STAFF REPORT

SUBJECT: Reveille Ridge Subdivision – AZ, PP

H-2023-0050

Annexation of 59.97 acres of land with R-8 (34.69 acres) and R-15 (25.28 acres) zoning districts; and Preliminary Plat consisting of 246 building lots and 38 common lots on 59.77 acres of land in the R-8 and R-15 zoning districts for the Reveille Ridge Subdivision.

B. Preliminary Plat (dated: 1/10/24) & Revised Phasing Plan (dated: 2/21/24)

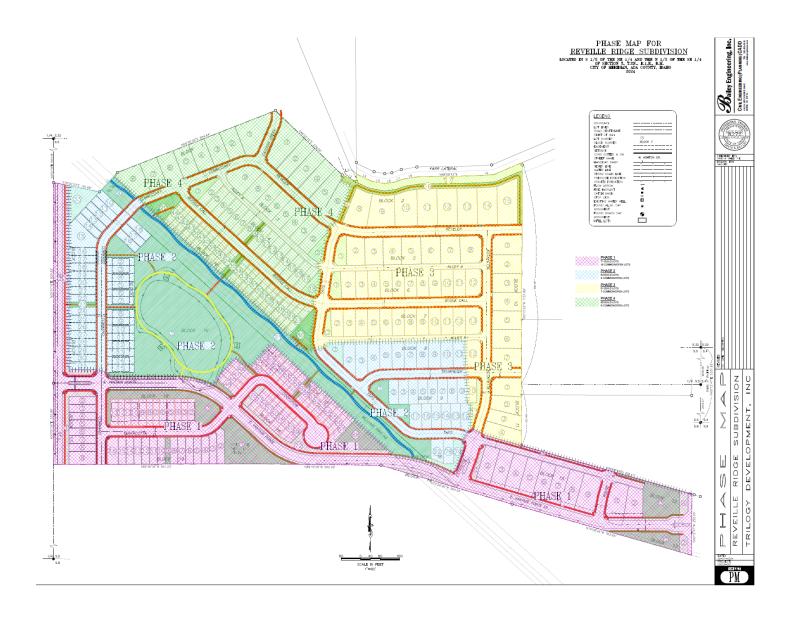
Phasing Plan: The subdivision is proposed to develop in four (4) phases per the phasing plan in Section VIII.B. The first phase is located along the southern boundary of the site and includes construction of all of the collector streets within the site. The second phase is the northeast portion of the development. The third phase is centrally located and contains the pond and most of the common open space for the development, including the linear open space in the Williams Pipeline easement. The fourth phase is the northwest portion of the development. **Staff recommends the phasing plan is revised to switch Phases 2 and 3 so the open space is provided in an earlier phase for the enjoyment of residents.** *The phasing plan has been revised as recommended.*

Sidewalks/Parkways (11-3A-17): For public safety, Staff recommends 10-foot wide detached sidewalks are provided along all collector and arterial streets within and adjacent to the site; parkways should comply with the standards listed in UDC <u>11-3A-17</u>. The plat and landscape plan, should be revised accordingly.

Landscaping: A minimum 25-foot wide street buffer is required along S. Eagle Rd., an arterial street, measured from *ultimate* back of curb location; and 20-foot wide street buffers are required along E. Vantage Pointe and St L, collector streets, per UDC Tables <u>11-2A-6</u> and <u>11-2A-7</u>. The buffer along E. Vantage Pointe on Blocks 12 and 15 needs to be fully landscaped, including the area on the back side of the sidewalk. Landscaping is required within the street buffers and parkways in accord with the standards listed in UDC <u>11-3B-7C.3</u>; the landscape plan should be revised to include a mix of landscaping materials and a calculations table that demonstrates compliance with the standards. All street buffers should be in a common lot or on a permanent dedicated buffer easement maintained by the property owner or homeowner's association; street buffers should be depicted on the plat accordingly and labeled as such.

- 2. The final plat shall include the following revisions:
 - a. Depict a minimum 20-foot wide street buffer in a dedicated buffer easement on lots adjacent to E. Vantage Pointe and St L, collector streets, labeled accordingly.

- b. Depict the future curb location as anticipated by ACHD along S. Eagle Rd.; and a minimum 25-foot wide street buffer, measured from the ultimate curb location.

- c. Depict 10-foot wide detached sidewalks/multi-use pathways within the required street buffers along all collector and arterial streets within and adjacent to the site (i.e. S. Eagle Rd., E. Vantage Pointe and St L).

- 11. Modify the phasing plan to switch Phases 2 and 3. Future development shall comply with the modified phasing plan in Section VII.B.
- 12. An administrative design review application shall be submitted for the single-family attached and townhome structures to ensure compliance with the design standards listed in the Architectural Standards Manual.

C. Landscape Plan (dated: 12/12/2023)

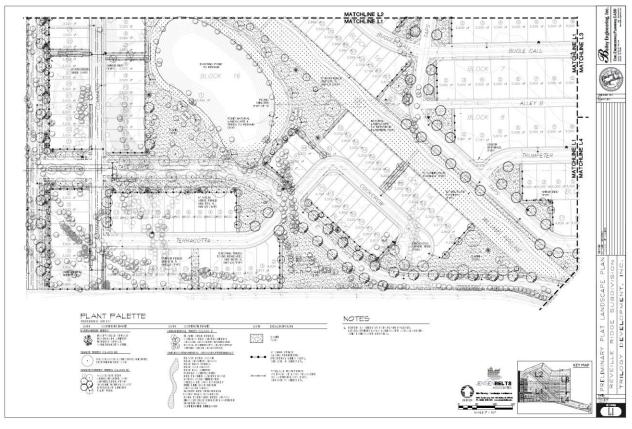
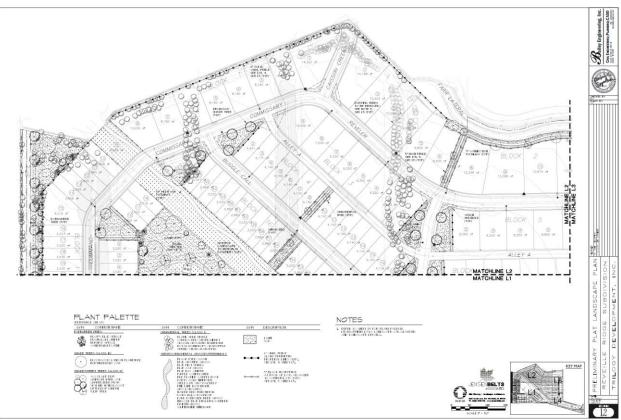
Landscaping, including trees and shrubs, should be depicted on the landscape plan within the 5' wide landscape strip on each side of all pathways as set forth in UDC <u>11-3B-12C</u>. Note: Alternative compliance may be requested for the trees along the pathway in the Williams pipeline easement as set forth in UDC <u>11-5B-5</u>.

There are several existing trees on the site – where possible, existing trees should be retained. Mitigation is required in accord with the standards listed in UDC <u>11-3B-10C.5</u>; calculations demonstrating compliance with the aforementioned standards should be depicted on the landscape plan.

Fencing: All fencing is required to comply with the standards listed in UDC <u>11-3A-6C</u> and <u>11-3A-7</u>, as applicable. The landscape plan depicts a mix of 6' tall vinyl privacy fencing and 5' tall wrought iron fencing.

Because there is a common lot with a pathway planned in Vertex Subdivision along the northern boundary of the site, Staff recommends the fencing in this location is changed to 5' tall wrought iron fencing to match that on the north side of the pathway and that proposed on this site to the east along the Farr Lateral in accord with UDC <u>11-3A-7A.7b</u>.

- g. Change the fencing type along the northern boundary on the western portion of the site adjacent to the common open space with a pathway in Vertex Subdivision to 5-foot tall wrought iron fencing in accord with UDC 11-3A-7A.7b.

- j. Include a detail for the picnic areas on Lot 1, Block 16 that includes tables, benches, landscaping and a structure for shade to demonstrate compliance with UDC 11-3G-4C.5.

- m. Depict a 5-foot wide landscape buffer planted with shrubs, lawn or other vegetative groundcover along the southwest side of the common driveway on Lot 51, Block 16 in accord with UDC <u>11-6C-3D.5</u>.
